Register Reference: SD22A/0303 Date: 08-Aug-2022

Development: Construction of a Volatile Organic Compound (VOC) Abatement system comprising of a thermal oxidiser (TO), associated plant equipment and scrubbers positioned on a bunded concrete plinth with a maximum single stack height of 12m along with two access platforms at 2.5 high and 5.0m high used for maintenance only; The system is set within a 489sq.m (including a bunded area of 213sq.m) concrete compound enclosed by a 2.4m high paladin weldmesh black fence to match the existing utilities perimeter fence; 135sq.m single storey utilities workshop will sit adjacent to the Volatile Organic Compound (VOC) abatement system compound with associated hardstanding area and soakpit; 55m (L) x 3.2m (W) x 5.6m (H) pipe rack extension with the addition of a second tier extension 118.6m (L) X 3.2M (W) 1.2m (H) to the existing pipe rack is required to service the new VOC abatement system compound; a contractor's compound 3,420sq.m comprising single stacked portacabins, workshops, parking for 30 contractors, materials delivery and set down area; the compound will be enclosed by a 2.4m tall paladin weldmesh black fence; modifications to the e

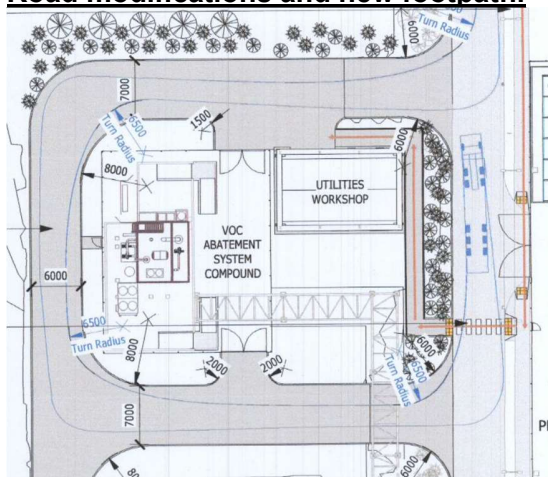
Swept path analysis is satisfactory.
Road markings & road signage needs to be detailed.
Footpaths do not meet minimum width criteria.

Applicant to ensure that pedestrian crossing adheres to section 4.3.2 of DEMURS re Pedestrian Crossings.

1. A revised drawing to be submitted prior to construction showing the footpath surrounding the VOC abatement system compound to be a minimum of 1.5m at all locations.
2. A revised drawing to be submitted showing road markings and road signage to include stop/yield bars and stop signs and to be in accordance with the Traffic Signs Manual.
3. Applicant to ensure that pedestrian crossing adheres to section 4.3.2 of DEMURS re Pedestrian Crossings.
4. Access road to be constructed as per Appendix 6 of SDCC TIC policy.
